## Product Change Notification / SYST-23QFBP679

ERRATA - AVR32DA28/32/48 Silicon Errata and Data Sheet Clarification Document Revision

## AVR32DA Silicon Errata and Data Sheet Clarification

Figure 3-1. Reset System Overview

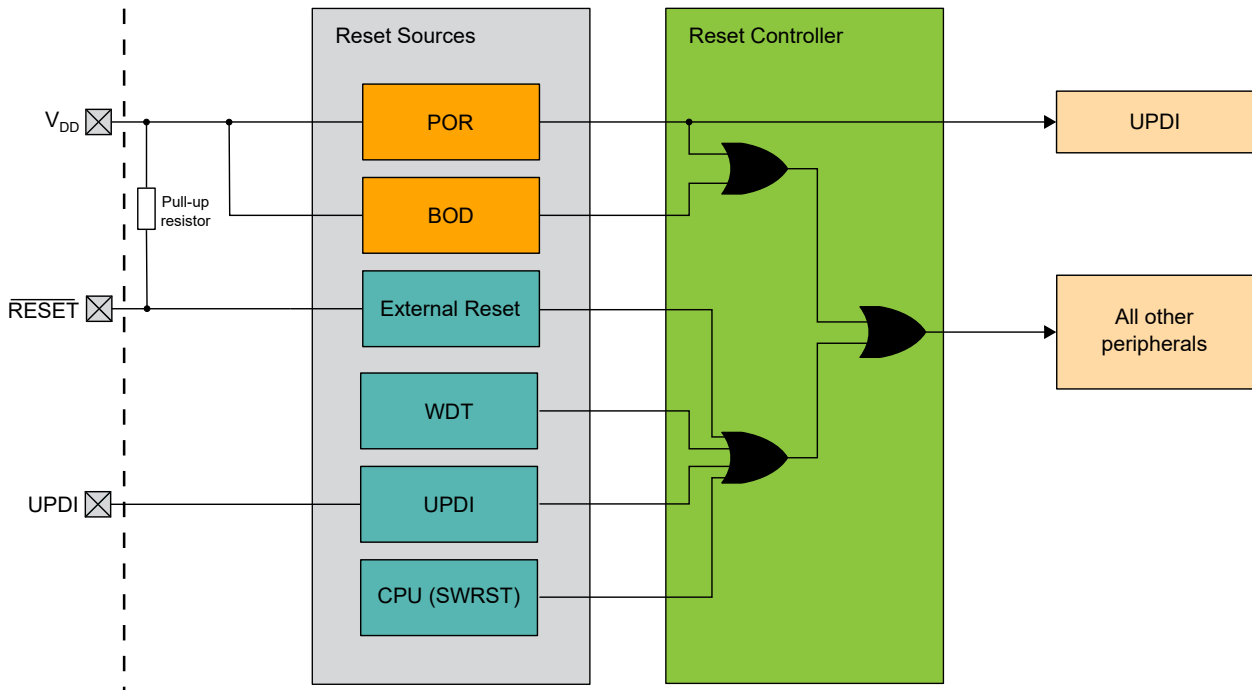
#### 3.3 RSTCTRL - Reset Controller

A clarification has been made to add the missing block diagram figure.
